6063B-04A-S

S E R V I C E N O T E

**6063B - DC ELECTRONIC LOAD SINGLE-INPUT
3-240 Volts. 0-10 A, 250 Watt**

POSSIBLE “SHOCK PINCH” HAZARD

“DEFECTIVE GROUND CONNECTION”

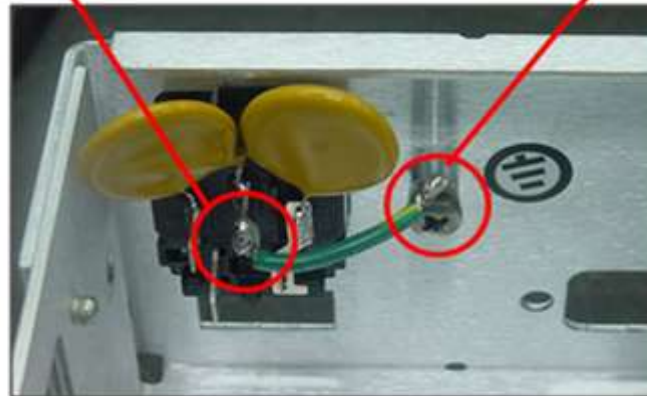
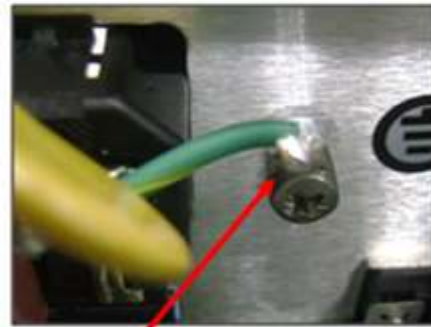
Refer to Figures “A” & “B” below. These figures are representative of insufficient solder connections at the ground pin of the AC INPUT MODULE and the instrument chassis ground.

If the Safety ground wire connections shown in Figures “A” & “B” do not meet or exceed acceptable solder connections as shown in Figure “C”, then the Safety ground connections must be repaired. Any person doing the repair must have the required knowledge to identify defective solder joints. It is also a requirement that the person doing the repair has the required skills to use hand tools and a soldering iron.

Figure “C”

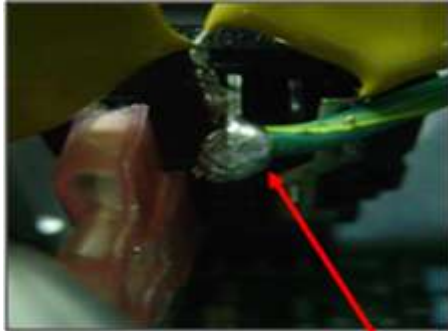
“ACCEPTABLE GROUND CONNECTION”
